Subject: Class 3 Permit Modification Request for the Waste Isolation Pilot Plant Hazardous Waste Facility Permit, Number NM4890139088-TSDF and Notification of Withdrawal Regarding the December 22, 2017 Determination of Class

Class 3 Permit Modification Request

Excavation of a New Shaft and Associated Connecting Drifts

**Waste Isolation Pilot Plant
Carlsbad, New Mexico**

Figure D-5-S#5
Fire-Water Distribution System (with S#5)

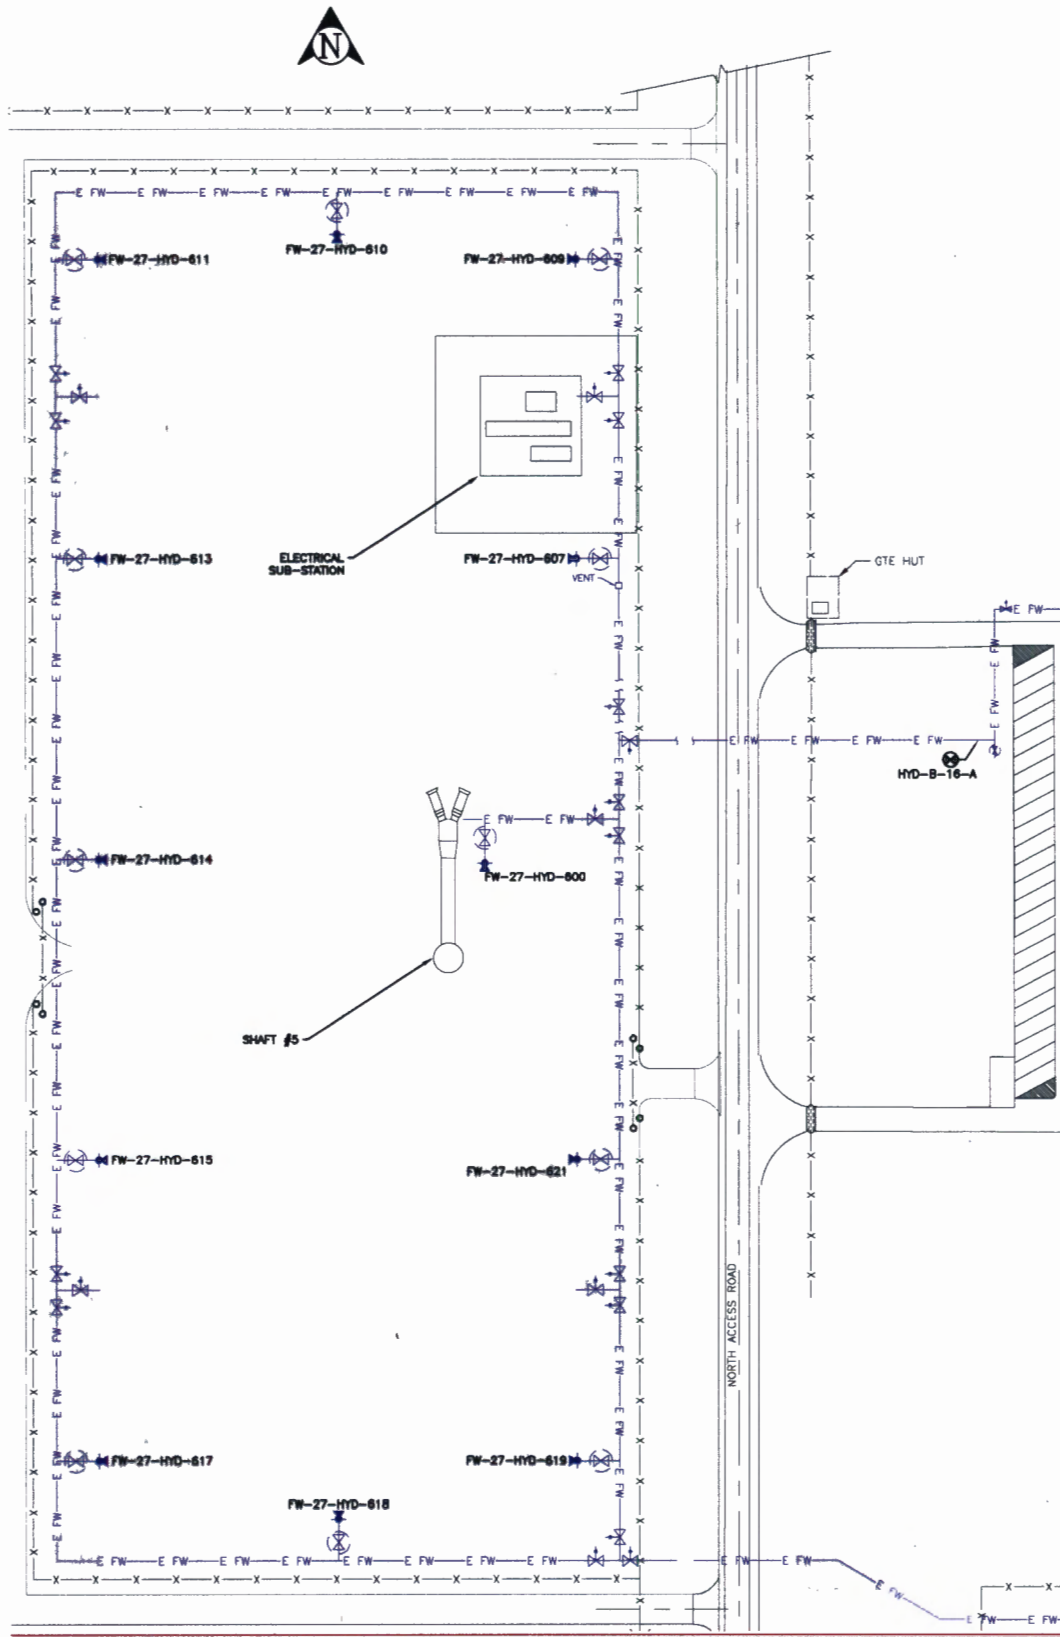
- One additional figure is being added to Permit Attachment D. Figure D-5-S#5, *Fire-Water Distribution System (with S#5)*, shows the fire-water loop and fire hydrants servicing S#5.

Attachment D, Figure D-5-S#5	Added new Figure D-5-S#5, <i>Fire-Water Distribution System (with S#5)</i> , after Figure D-5.
Attachment D, Figure D-7	Replaced Figure D-7, <i>Designated Underground Assembly Areas</i> , with new figure.
Attachment D, Figure D-8	Replaced Figure D-8, <i>WIPP Site Evacuation Routes</i> , with new figure.
Attachment G, <i>Introduction</i>	Deleted "the four" before shaft and added "for each shaft" after systems in first paragraph of the introduction.
Attachment G, Figure G-1	Replaced Figure G-1, <i>Location of Underground HWDUs and Anticipated Closure Locations</i> , with new figure.
Attachment G, Figure G-6	Replaced Figure G-6, <i>Approximate Locations of Boreholes in Relation to the WIPP Underground</i> , with new figure.

Figure D-8
WIPP Site Evacuation Routes

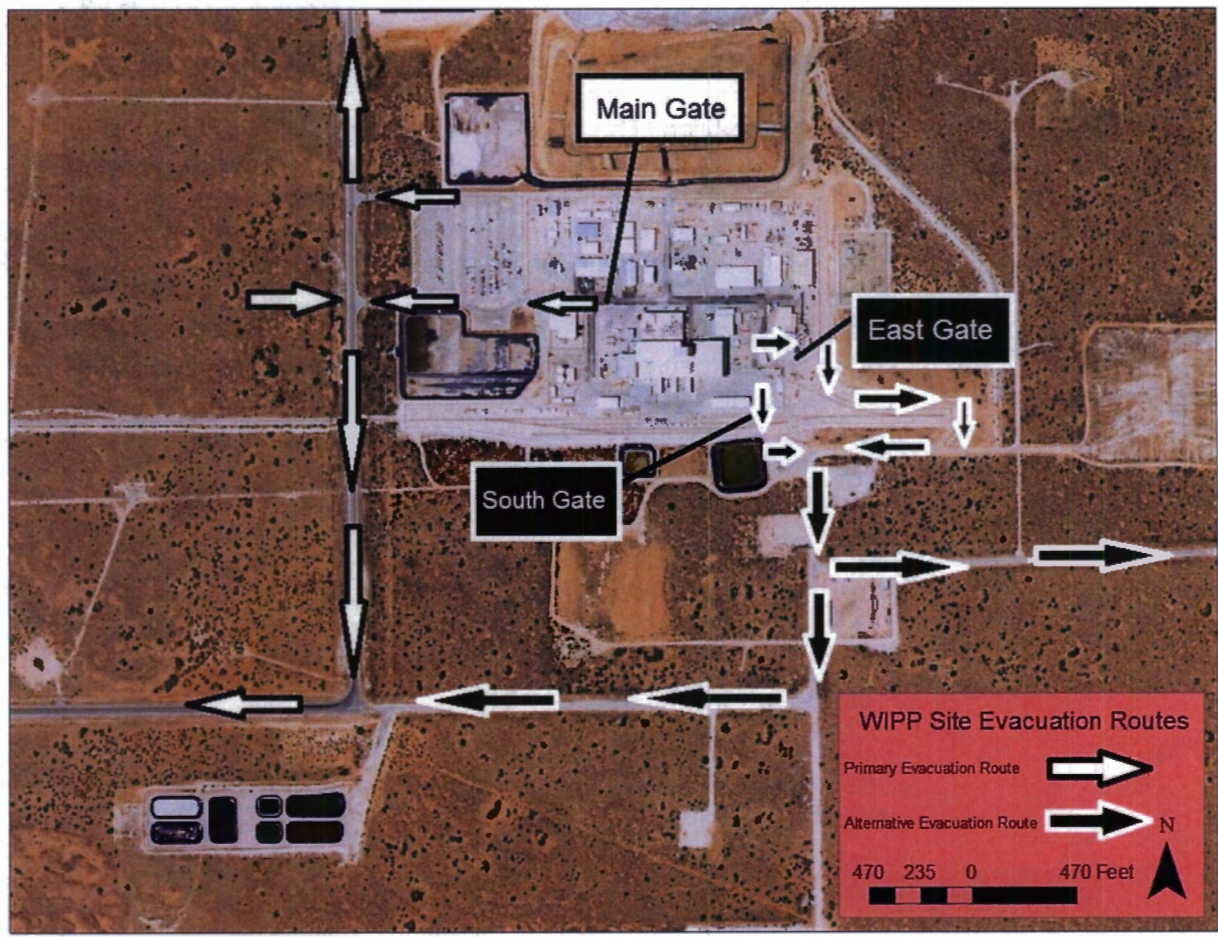
- Permit Attachment D, Figure D-8, *WIPP Site Evacuation Routes*, is being modified to show the evacuation route from the S#5 area on the west side of the North Access Road.

Attachment D, Figure D-8	The <i>WIPP Site Evacuation Routes</i> figure is being modified to show the evacuation routes from the S#5 area. This change is needed to update the Permit with the information pertaining to S#5.
Attachment G, Introduction	This section is being modified to show that the shaft seal systems apply to all shafts, not "the four" shafts as is currently stated. This change is needed to update the Permit with the information pertaining to S#5.
Attachment G, Figure G-1	The <i>Location of Underground HWDUs and Anticipated Closure Locations</i> figure is being modified to show the location of S#5 along with the planned drifts to connect the shaft to the underground facility. This change is needed to update the Permit with the information pertaining to S#5.
Attachment G, Figure G-6	The <i>Approximate Locations of Boreholes in Relation to the WIPP Underground</i> figure is being modified to show the location of S#5 along with the planned drifts to connect the shaft to the underground facility. This change is needed to update the Permit with the information pertaining to S#5.
